WATERBURY FILING NO. 1

CONSTRUCTION SET

GRADING AND EROSION CONTROL PLAN

OUTLET STRUCTURE MODIFIED TYPE 1 MH

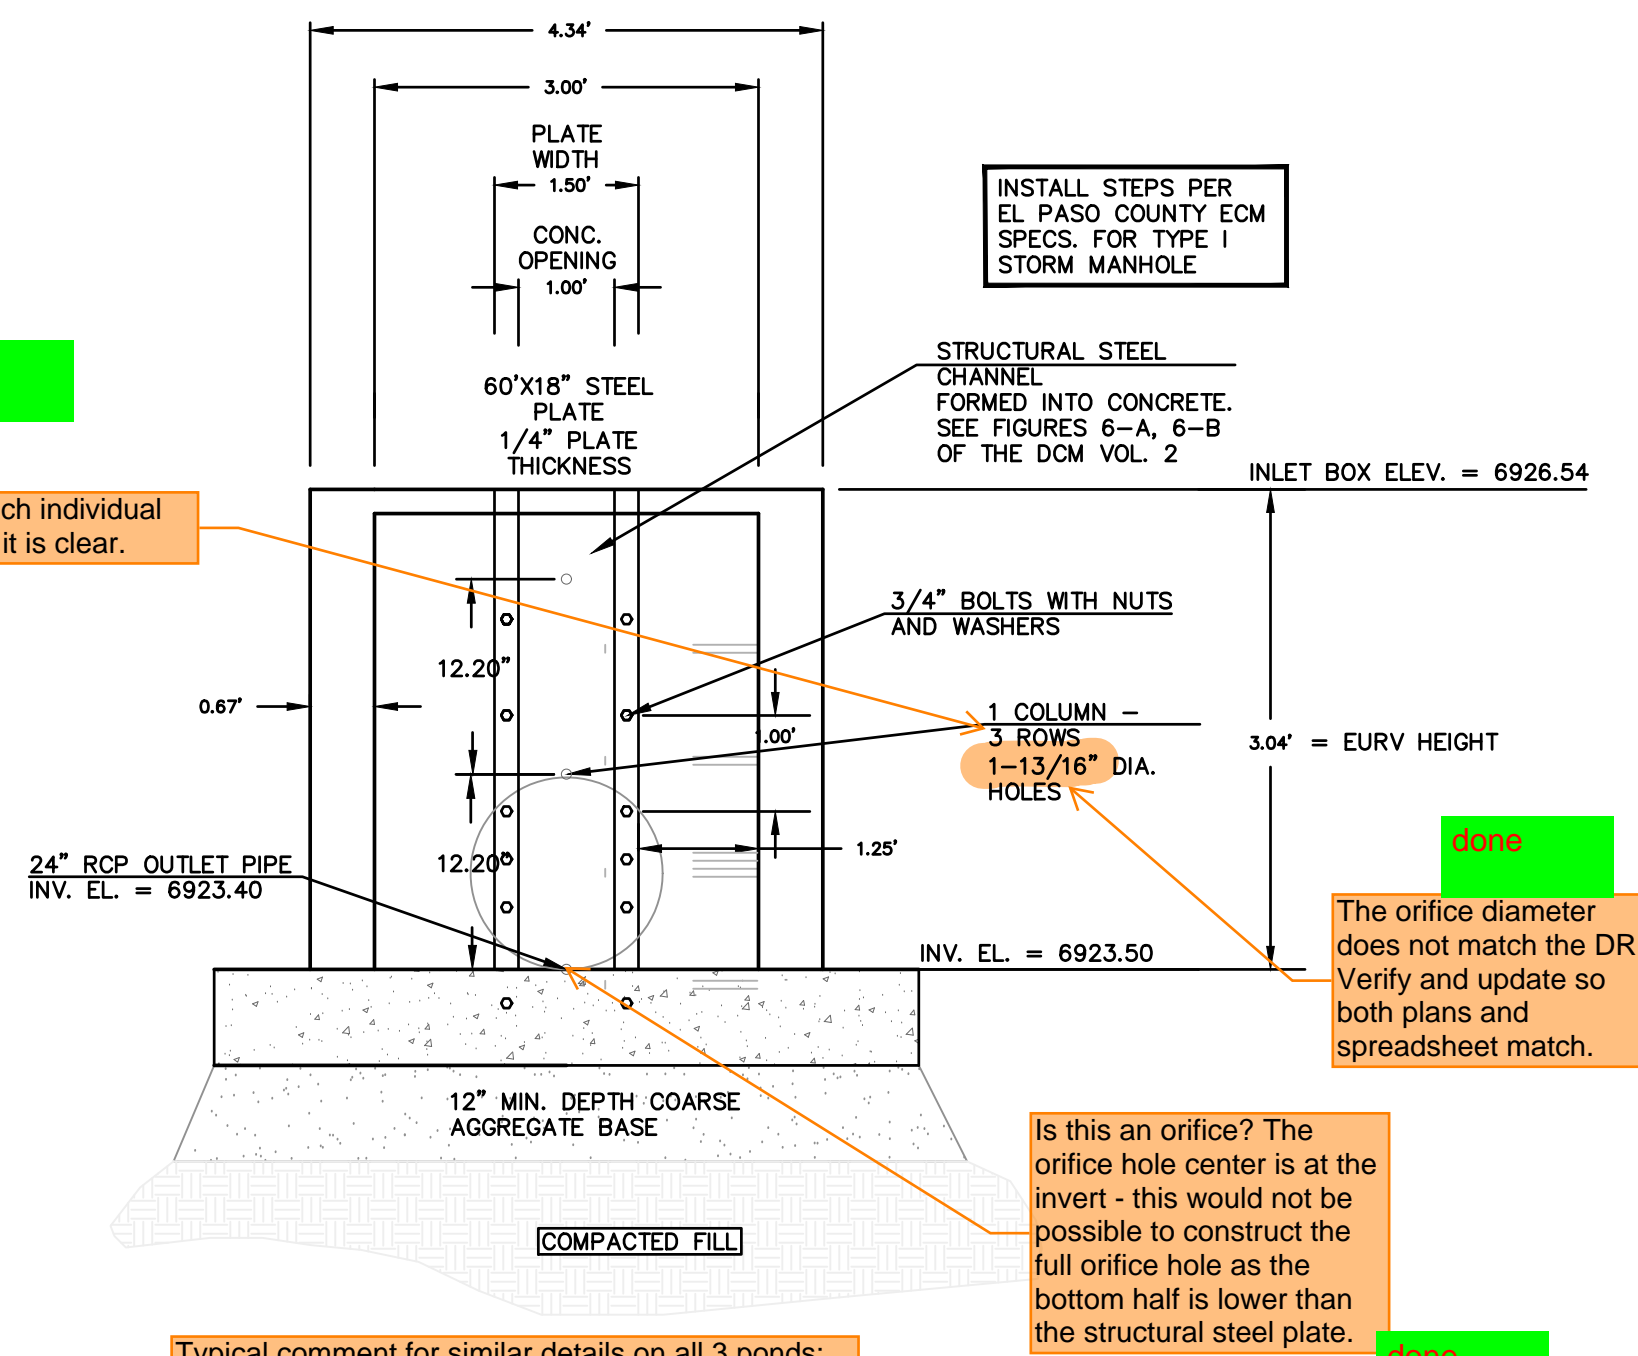
Typical comment for all 3 ponds:
Include callout for pet waste station(s) around the pond, with signage stating that pet waste must be picked up.

Typical comment for all 3 ponds:
Provide maintenance access road detail/cross section, including stone sizing and gradation. Show cross slope at 2%.

Trash rack to be Amico Klemp KRP Series aluminum bar grate (Figure 6-b), US Filter or Johnson stainless steel well screen with #93 VEE wire (Figure 6-a), or equivalent (per EPC DCMv2, Chap 4.3 and MHFD Detail T-12).

Diamond plate trash racks are not an equivalent replacement to those in our criteria. We have concerns that the diamond plate is going to be a constant maintenance issue with clogging. Diamonds plates may have the same percent open area as those shown in our criteria but this isn't the only criteria that decides equivalency with the ones specified in our criteria. The well screen and bar grates in our criteria are designed to be maintenance friendly whereas the diamond plate will clog more often.

Wellscreen and concrete channel between wellscreen and orifice plate should extend down to the bottom of the micropool per MHFD Detail T-5, page EDB-5.

Does not match detail below or what is shown in DR calcs. Revise to remove discrepancy.

Typical comment:
Provide depth of concrete for all pond structures.

Callout each individual orifice, so it is clear.

Typical comment for similar details on all 3 ponds:
Pond bottom should have a minimum slope of 3% to the trickle channel and micropool (USDCM Vol 3, detail T-5). Please adjust to minimize future maintenance needs.

Typical comment for similar details on all 3 ponds:
Consider having control joints every ~10ft.

Per MHFD Detail T-5, a longitudinal slope between 0.4-1% is recommended to encourage settling while reducing the potential for low points.

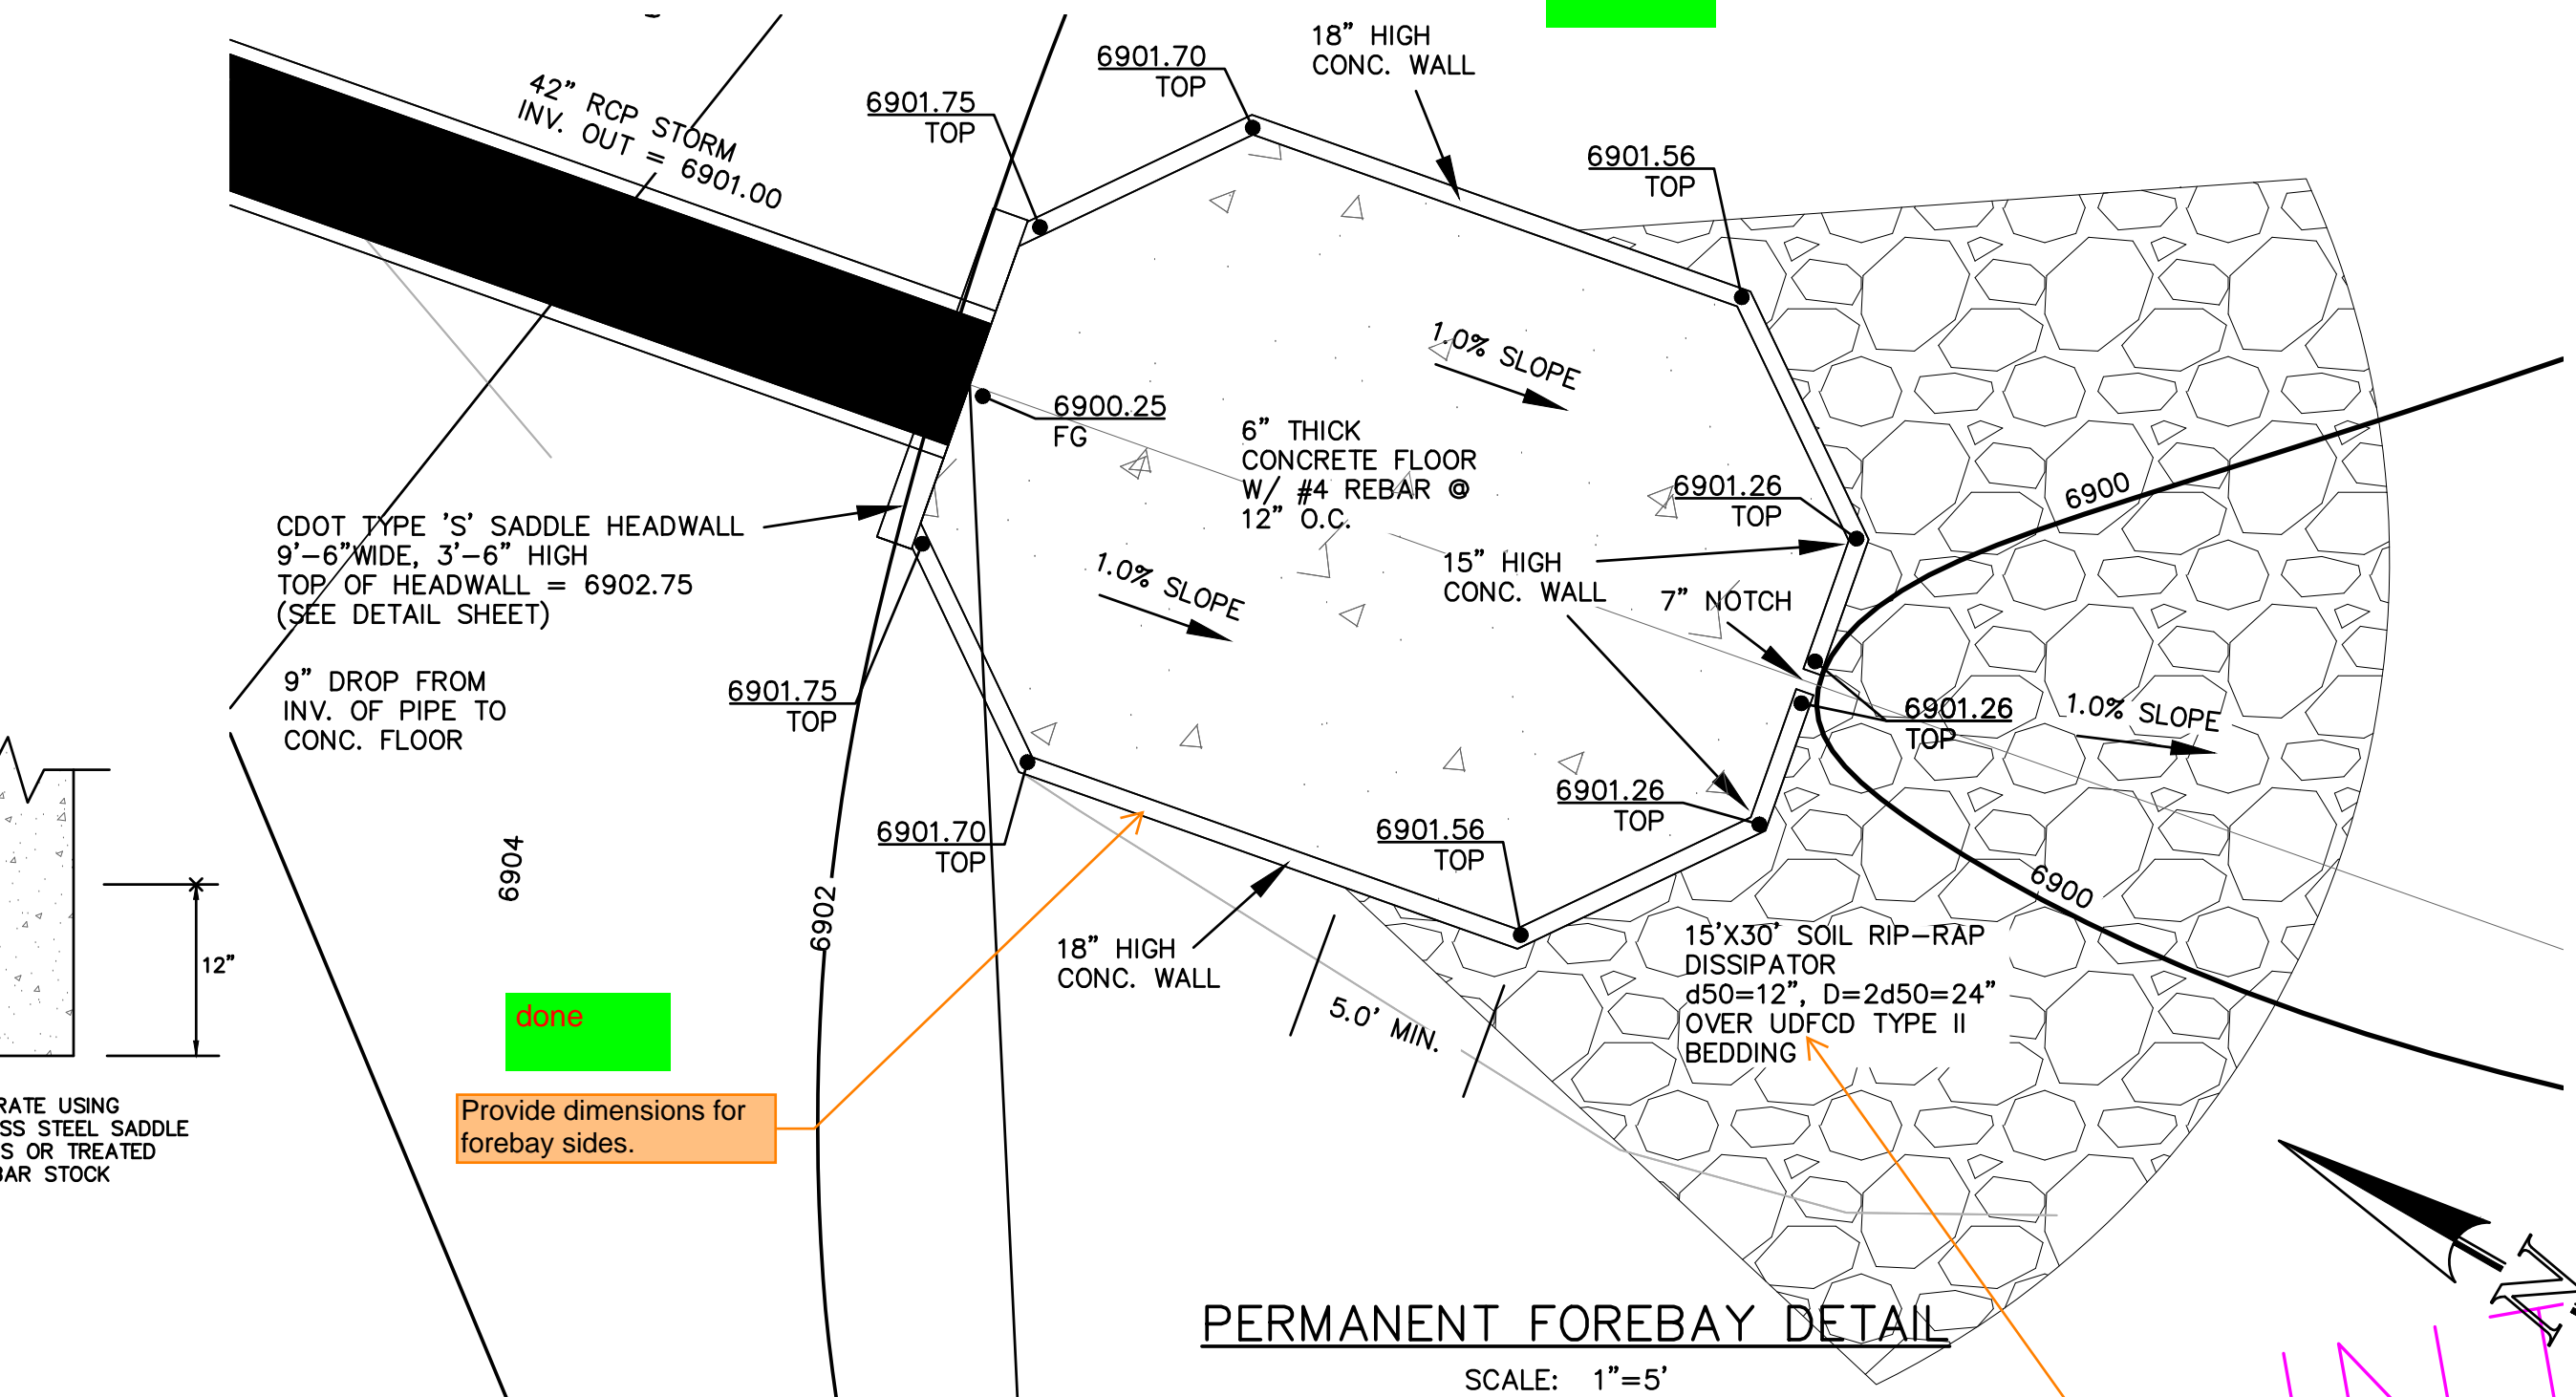
Values do not match D spreadsheet. Verify and update so both match.

Provide dimensions - The pad proposed is not rectangular 15'x30'. If the design is intended to be at an angle point and arc as drawn - update dimensions.
